3. **Rezoning and Development Permit with Variances Application No. 00489 for 2035 Stanley Avenue**

**Subject:** Rezoning Application No. 00489 for 2035 Stanley Avenue

The purpose of this report is to present Council with information, analysis and recommendations for a revised Rezoning Application for the property located at 2035 Stanley Avenue. On January 14, 2016 the Planning and Land Use Committee passed a motion directing staff to assist the applicant to revise the proposal, particularly in relation to improving the height and massing of the building and reducing the variances. As with the previous proposal, the revised proposal is to rezone from the current R1-B Zone, Single Family Dwelling District, to two new site specific zones in order to subdivide the lot, keep the existing non-conforming duplex and build a new small lot house. Changes to the proposal include reducing the height by 0.30m and altering the roofline to make the massing of the building appear smaller.

Title: SITE PLAN & SITE DATA

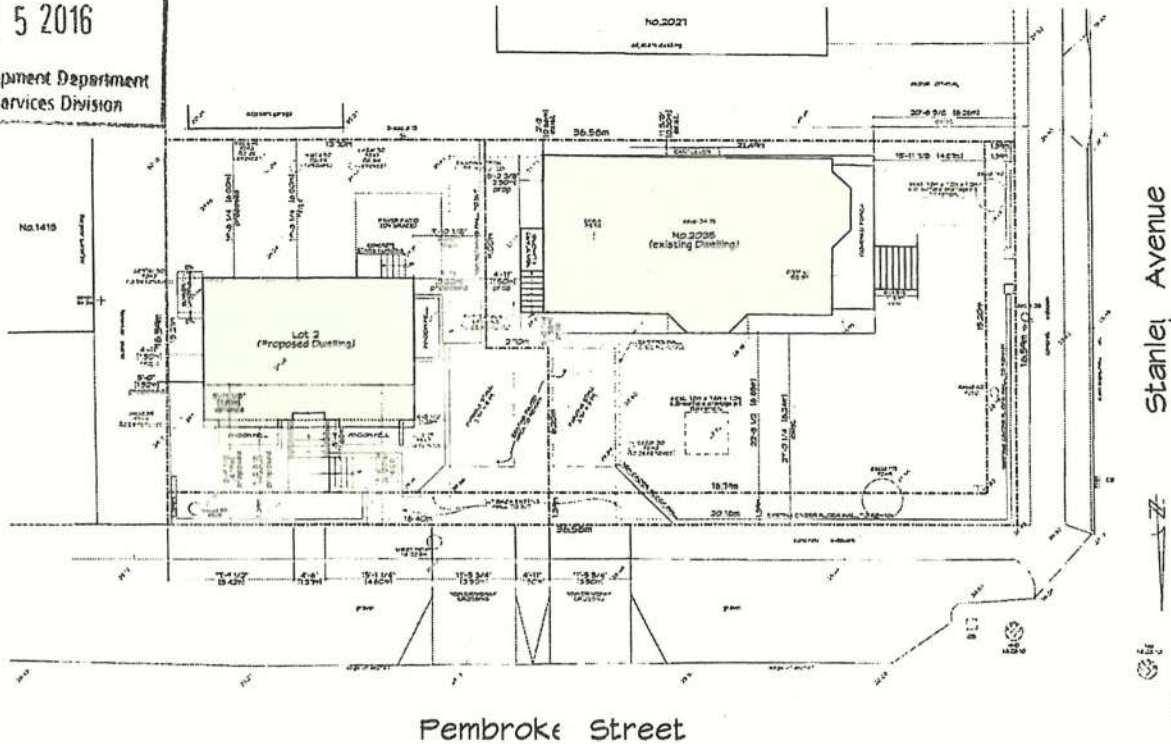
REV. NO.	DESCRIPTION	DATE	REVISION
1	AVG. GRADE RECALCULATED TO INCLUDE RM FINISHES. SPREAD LAYERS ADDED TO SITE PLAN. STAIRS MODIFIED TO ACCENT FOR BUILDING HEIGHT REDUCTION.	MAY 18/16

Title:  
LOT 2  
FLOOR PLANS &  
ELEVATIONS

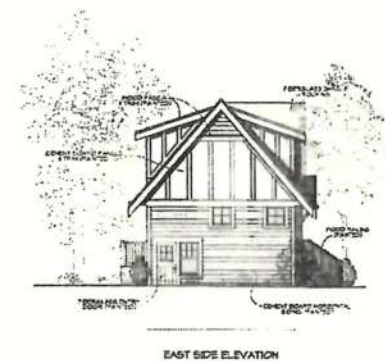
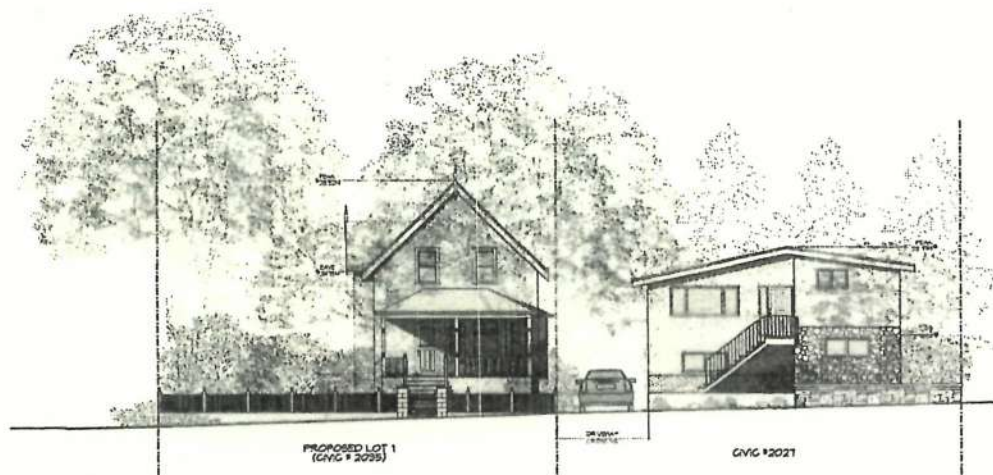
REV	NO	DESCRIPTION	DATE	Revised by	Sheet
1		ROOF SCALE OF GABLE END ON FRONT ELEVATION CHANGED BUILDING LOWERED 1'-0" INTO THE GROUND 1 OF WINDOWS REDUCED ON EXTERIOR STAIRS PUNCH LANTERN ADDED TO FLOOR PLANS 1 & 2	MAY, 11/15		SK 2.1 Proj No. 180
